Final Environmental Assessment for the Microreactor Applications Research, Validation, and Evaluation (MARVEL) Project at Idaho National Laboratory

June 2021

Prepared for the
U.S. Department of Energy
DOE Idaho Operations Office

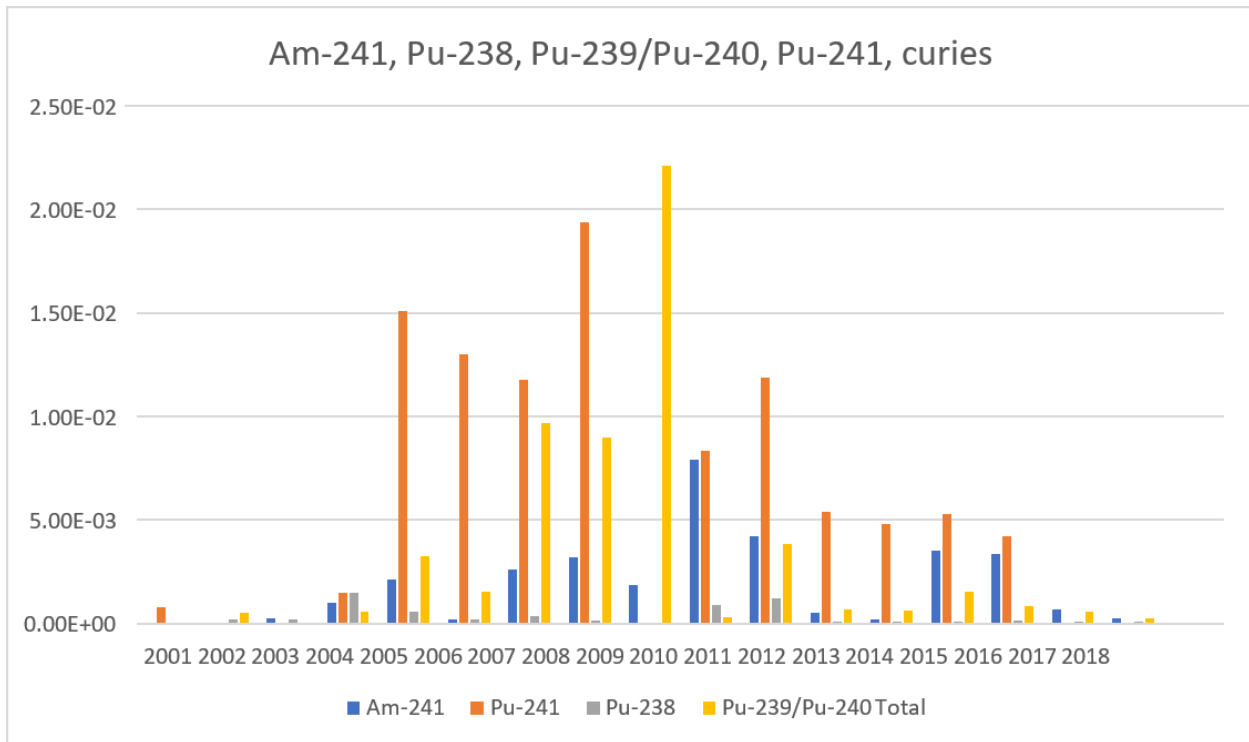
The EA fails to address the inadequate and actually fraudulent environmental monitoring by its contractors, including the annual environmental surveillance report contractor, which incorrectly attributes americium-241 from the INL to past nuclear weapons testing.[70]

Take a look at the plutonium and americium-241 releases from the Idaho National Laboratory between 2001 and 2017 based on Department of Energy environmental monitoring reports.¹⁶ The State of Idaho DEQ does not display, report or trend any data before 2013....and I can see why. The huge releases

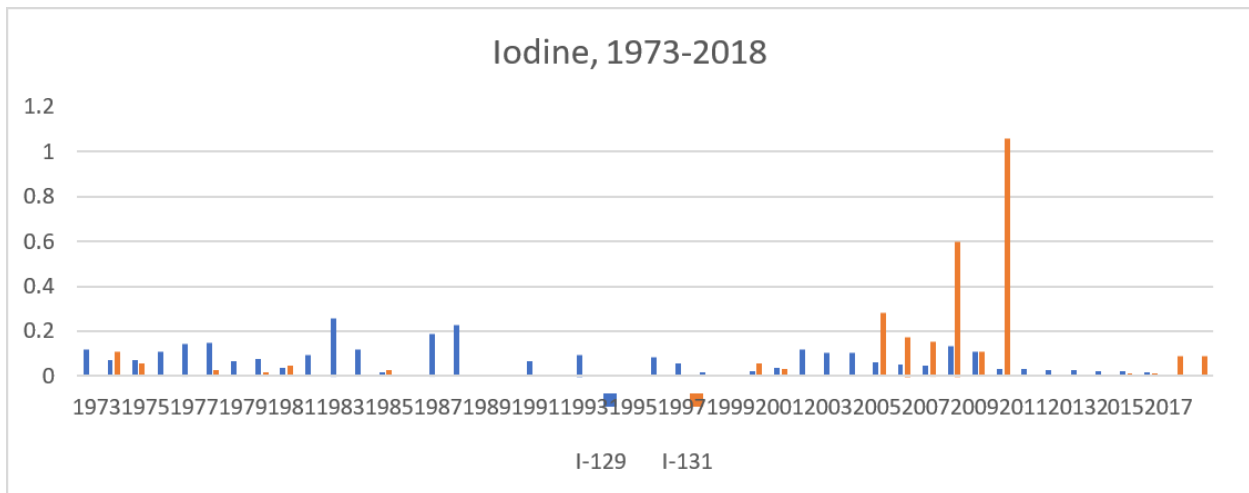
Then let's take a look at the iodine-129 and iodine-131 releases between 1973 and 2017, in curies. The State of Idaho DEQ went from displaying all of their environmental monitoring reports to displaying ten years of the reports, to now displaying only six years of annual reports and only 4 years of quarterly data reports from 2013 to 2018. **Again, here you can see why the Idaho DEQ didn't want to display INL monitoring data before 2013.**
